NY8L SPI Flash Application Notice

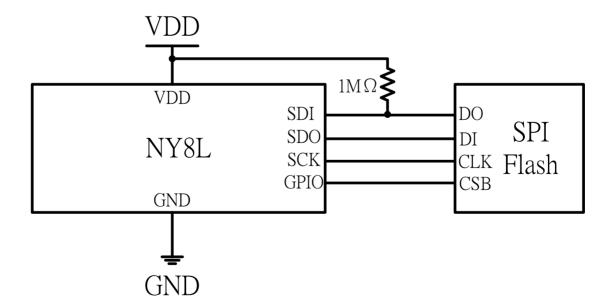
Description: NY8L enables the SPI function. In standby or sleep mode, SDI affects the standby current due to the floating state.

Reason: The SPI function of NY8L series is enabled or disabled by using option. When the SPI is enabled, its corresponding GPIO configuration will remain in SPI mode, and the configuration cannot be changed through the program. SPI interface configuration is as follows:

SDI: Input Floating (This interface will remain floating state when the SPI Flash is not active.)

Because of the component characteristics of SPI Flash, there are multiple SPI Flash parallel connections. Therefore, when the CSB signal is not enabled, all the pin states of the SPI Flash will be floating, and the NY8L SDI interface will remain floating state.

Solution: When the SPI function is enabled, it is recommended to connect a pull-up resistor to the SDI interface $(1M\Omega)$.
